Your Ref
Our Ref 2464LR02-1/NHF

15th July 2015

Geoenvironmental Investigation for Solar Farm Development, Acrefair, Near Wrexham – Updated Investigation Specification

Figure 2: Site Location and Approximate Location of Re-Deposited 'Monsanto' Wastes

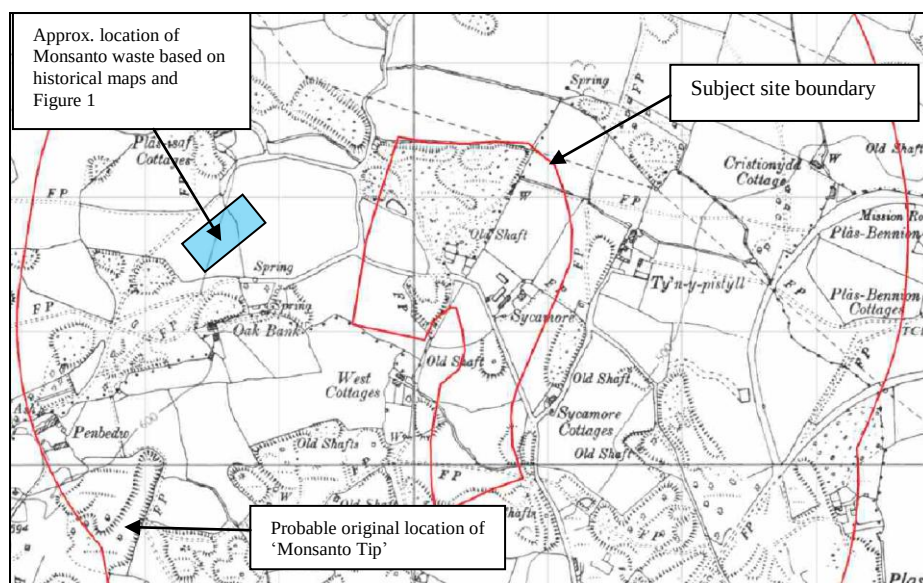
Assessment of the location of the re-deposited materials, in comparison to the site boundary and historical maps shows the location of the re-deposited 'Monsanto' waste is not located on the site (see Figure 2).

- Original location of the 'Monsanto' waste is not fully known, and cannot be investigated as possible location is off site (see Figure 2);
- The new location of the 'Monsanto' waste is approximately 300 m to the west of the site;
- The wastes are deposited approximately 37 m below ground level;
- Investigation of these waste materials cannot be undertaken;

Figure 3: Proposed Lake Location from Restoration Plan

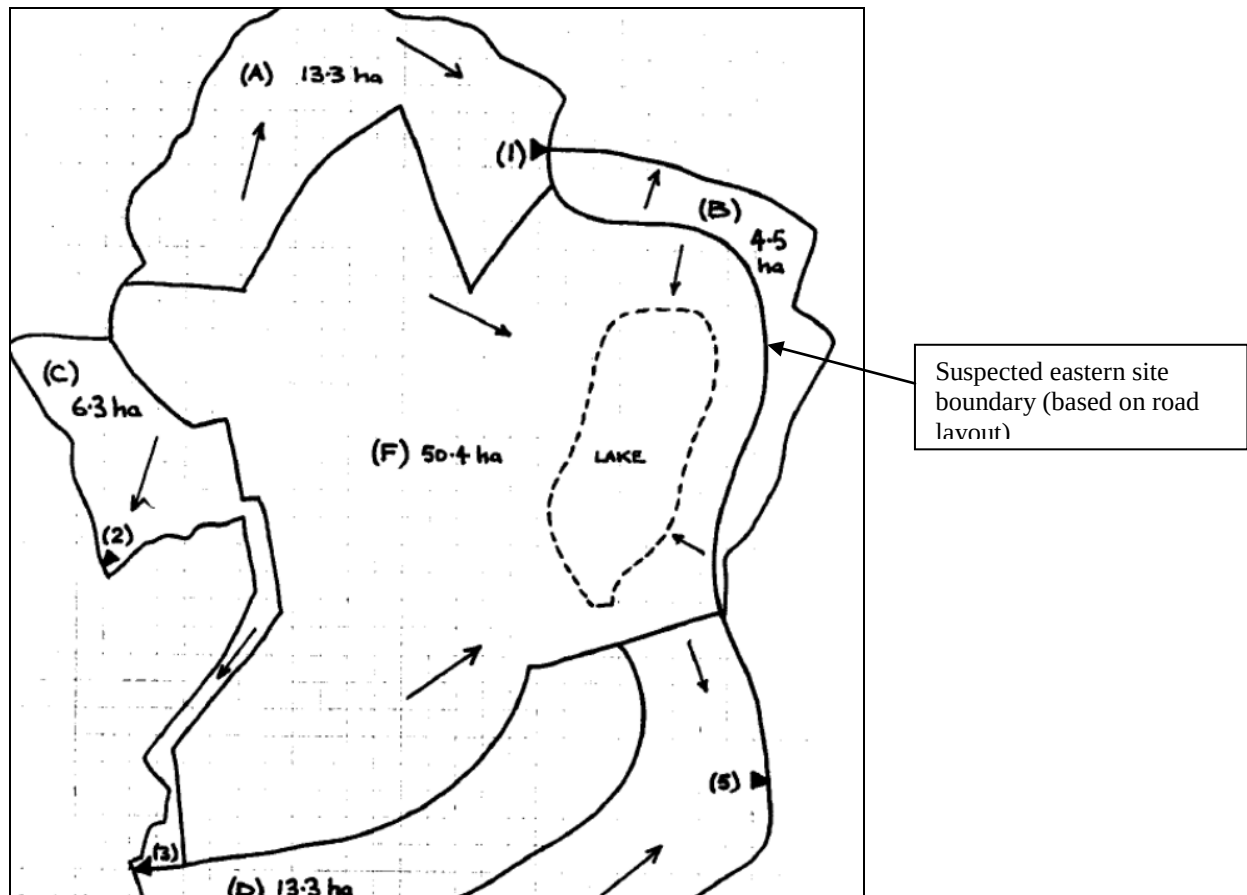
The borehole location plan of the intrusive investigation does not contain enough information to allow for the locations to be properly assessed. Therefore, in terms of the potential location of the pond / lake area, information has to be obtained from the restoration scheme. Figure 3 below shows the proposed location of the lake.

- It is possible that the gas works waste is located in the northeastern part of the site;
- The has works waste is likely to be located within the top 5 m of the site, based on available information relating to depth to materials and possible draining and infilling of the lake;
- Deeper intrusive investigations should be concentrated in the northeastern part of the site to investigate potential relatively shallow gas works waste.

Figure 4: Proposed Exploratory Hole Locations

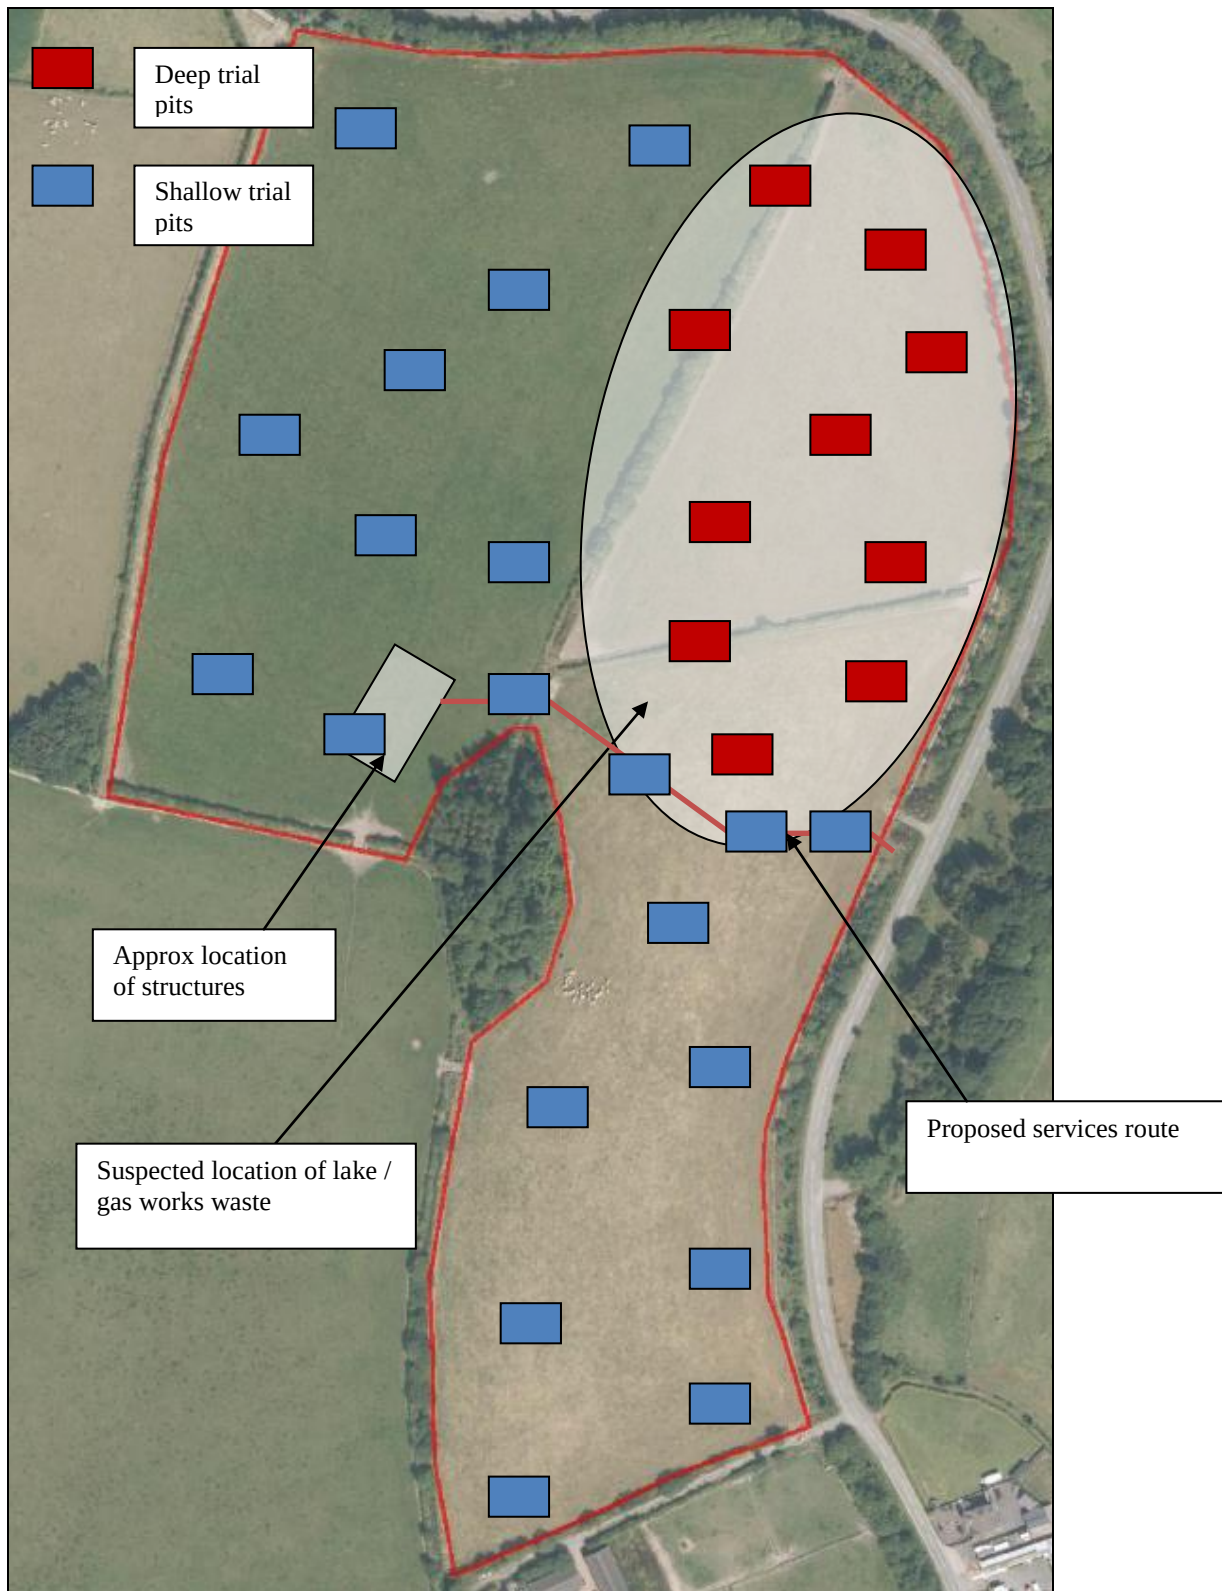
Based on the above information , the overall scope of works we do not proposed to change from the original specification presented in our letter reference 2464L01-1/CSE. However, rather than 10 samples being targeted at the 'Monsanto' wastes, which have been shown to

not be located on the site, these samples will be concentrated in the northeast of the site to investigate potential relatively shallow gas works wastes.

An additional 20 samples will be distributed across the site, targeting the proposed buildings, proposed service trench as well as randomly distributed across the proposed area of the solar farm.

Additional sampling will be spread across the site to provide coverage. In addition, samples will be taken in close proximity to the proposed enclosed structures where maintenance staff / site engineers will be based. In addition, samples will be taken where excavations for service provision are planned. Figure 4 below shows the proposed exploratory hole locations:
